Climate Adaptation Scilly
Porthmellon Enterprise Centre
St Mary's
Isles of Scilly TR21 0LW

Our ref: CAS-EA1
Your ref: P/22/076/FUL
P/22/077/FUL
P/22/078/FUL

APPLICATION FOR THE INSTALLATION OF GEOBAGS AT PERIGLIS TO REPLACE THE CORE OF EXISTING DUNES, WRAPPED IN GEOTEXTILE AND COVERED WITH EXCAVATED MATERIAL AND TO STABILISE THE DUNE CREST WITH GEOMAT TO ENCOURAGE RE-VEGETATION. INSTALLATION OF ROCK BAGS AT PORTH COOSE TO HEIGHTEN THE EXISTING PROTECTION, BACKED BY EARTH BUND AND INSTALLING ROCK ARMOUR AT THE BOTTOM OF THE EXISTING SNE WALL AT PORTH KILLIER. TO REDUCE THE RISK OF COASTAL FLOODING ON ST AGNES. (EIA DEVELOPMENT) (MAJOR DEVELOPMENT) LAND ADJ TO WASTE SITE, THE QUAY, ST AGNES, ISLES OF SCILLY

Thank you for providing the objection raised by Natural England (NE) on 12 January 2023, their reference 513542.

Figure 1: Porth Coose: Plymouth Coastal Observatory data obtained from three beach profile transects (2007 – 2020).

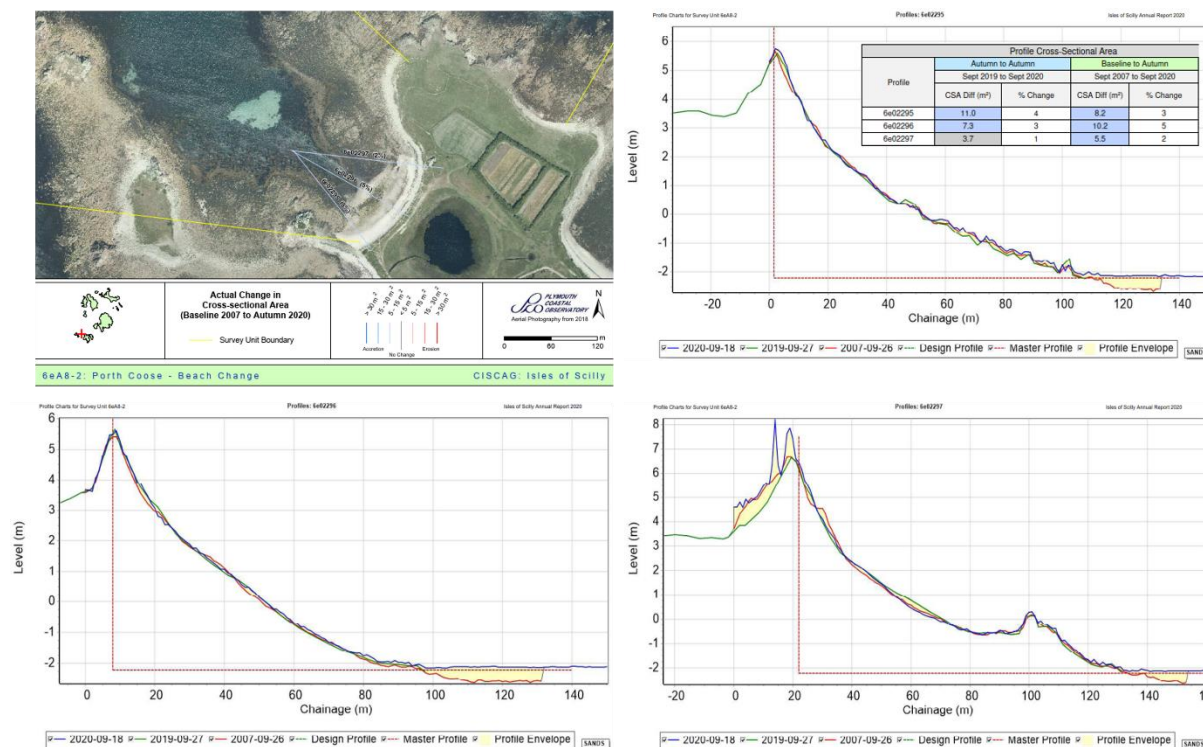
15) The majority of works are to the rear of the crest and we understand that there is no space for a setback option, so it appears that all avoidance options have been explored. Increasing the height will increase wave reflection, but the upper part of the beach is already protected by a concrete mattress, so the risk to the upper beach face profile is minimal. Over time, it is likely that more of the concrete mattress could become more exposed. The ES notes that some parts of it are already exposed as cobbles have been thrown over the crest during large storm events. Increasing wave reflection could increase cobble mobilisation at the top of the beach during large storms, but it is unlikely to significantly erode due to the size of the material and the presence of the mattress.

The concrete mattress is unlikely to become more exposed over time, because the proposed rock bags at the crest of the existing sea defences will prevent cobbles from being thrown over the defences during high seas, and thereby being lost to the beach frontage as happens at present.

At present the cobbles that are found on the beach are mobilised by storm waves and photos indicate that these are periodically translocated to the landward side of the crest via overwashing. The placement of the rock bags will considerably reduce overwashing meaning a reduction in loss of cobbles from the beach.

The question remains whether this will lead to exposure of the concrete mattress. Photos show that in small pockets the mattress is already exposed. During storm events it would be expected that beach sediments (predominantly sands, gravels and cobbles) would be mobile within the tidal frame, and possibly beyond. Given the placement of the rock bags there is potential for sediment to be drawn down from the upper beach profile to be deposited lower down in the tidal frame, thus exposing the rock mattress to erosive wave forces. If exposure occurs and the mattress is subject to repeated storm wave activity there is potential for it to be damaged.

However, it is expected that the sediment transported down the beach profile would later be re-deposited higher in the profile under reduced wave conditions. Wind-blown sand may also add to accretion at the backshore, perhaps more so given the presence of the rock bags reducing material lost over the ridge.

Notably, repeated beach topographic surveys suggest that the beach has accreted in cross-sectional area between September 2007 to September 2020 (as well as between September 2019 to September 2020), see table. Most of this accretion has occurred at the lower and upper limits of the three profiles.

It could be suggested that exposure of the rock mattress is likely to be a seasonal issue rather than a long(er) term trend.

The profile data suggests that sediment appears to be accreting at lower tidal elevations along each of the transects, with more limited levels of accretion higher in the tidal frame. Profile 6e02295, in the SW of the embayment has accreted sediment at the crest ridge when compared with the 2007 baseline and the previous year's survey. Profile 6e02297, to the NE of the bay saw minor sediment gains and losses on the seaward side at the crest ridge with sediment gains on the landward side of the crest when compared with the 2007 baseline and the previous year's survey.

This material is likely to have been mobilised by wave activity and overwashing. The consequence being this sediment has been lost from the beach system; notably this material would not have been overwashed had the rock bags been in place.

Collectively the three profile transects, and associated profile cross sectional area (CSA) suggests the beach at Porth Coose has accreted sediment between September 2019 to September 2020 and between the September 2007 (baseline) to September 2020 (Table 1).

Figure 1: Actual changes in cross-sectional area at Periglis beach, from autumn 2007 to autumn 2020. Positive percentages would indicate accretion, while negative percentages would indicate erosion. All cross sections at Periglis show no change or up to 4% accretion over this period (PCO 2020).

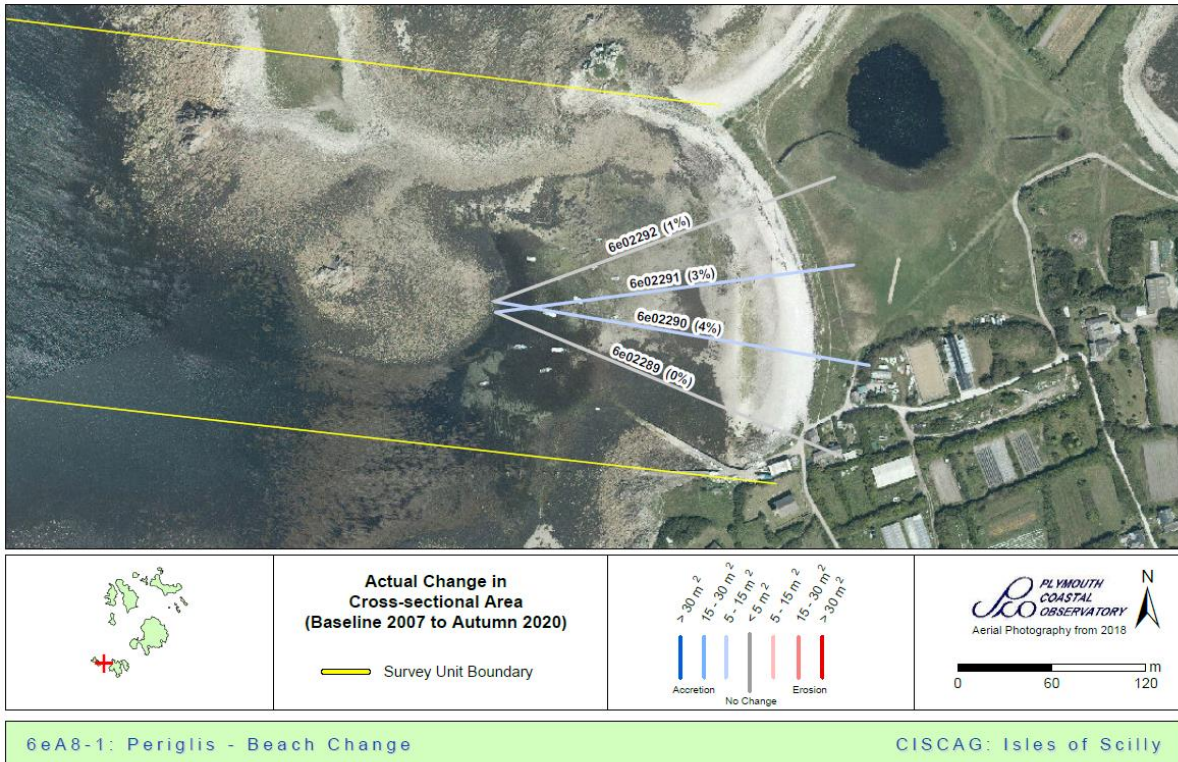
16) The ES indicates that the dune ridge appears to be in a long-term erosional trend, with evidence of erosion and oversteepening in some locations. Sand-filled dumpy bags were placed on the seaward edge of the dune ridge following the 2014 event in an attempt to reduce further erosion. Although some accretion has been noted around bags, this should not detract from the fact that the long-term trend for the dune ridge is erosional. During storm events, sediment is eroded from the existing dune face, causing steepening and retreat of the ridge. With rising sea levels, erosion of the dune ridge would be anticipated to accelerate.

As the long-term trend of the existing dune crest is predominantly erosional, it can be inferred that both advancing the alignment of the dune crest seaward and raising the elevation of the dune crest within the proposed design is highly likely to exacerbate erosion of the dune face during storm events. As the defence prevents natural rollback, the dune face will become sacrificial, and exposure and undermining of the geobags will occur, as has been observed on other wave-exposed sites where the net dune sediment budget is negative. On exposure of the vertical, resistant surface of the geobags, wave reflection is likely to occur, which could subsequently erode and steepen the beach face. The strandline as viewed on aerial imagery is overlapping with the toe of the proposed defence; therefore, it would be anticipated that this sensitive area would be subject to erosion following construction of the defence.

The SMP policy for this unit is Hold The Line for all three epochs. However, alternative options, such as a setback defence, could significantly reduce impacts on the SSSI and should therefore be fully considered.

Although Natural England rely on the Environmental Statement (ES) for part of their objection information, the ES is inaccurate.

The independent Plymouth Coastal Observatory annual surveys for this beach from 2007 to 2020 shows that the trend for Periglis is actually accretional (Figure 1). These data include observations both before the 2014 storm and after the 2014 storm.

As with Porth Coose, some elements of the ES Coastal Processes chapter will be amended to better reflect the Plymouth Coastal Observatory data and present it so that it provides a more representative assessment of the condition of the beach.

Beach profile data suggest an overall increase in CSA along 3 of the 4 transects with marginal losses on one transect (6e02289) when compared against the baseline (Table 2).

Despite this actual positive trend to accretion at Periglis over this 13-year period, the project proposes to move the geobags further back within the dune in response to the objection. Shifting the geobags rearward will increase the volume of material excavated. In the northern part of the dune, this is likely to remove the dune entirely before reconstruction is undertaken. The project proposes to move the bags back 3 m laterally compared to the

originally submitted designs towards the back of the dunes, to minimise the volume of additional material to be excavated and associated increased costs.

This design modification is not likely to change the environmental impact of the proposed works, but it is likely to require working more frequently from behind the dunes at Periglis, rather than from the beach. The existing red line diagram provides adequate space in which this form of working can take place.

The placement of the geobags and broader design specification may require further consideration. Whilst limited profile data suggests an accretionary trend the expectation would be for the beach at Periglis to narrow in time as a response to sea level rise.
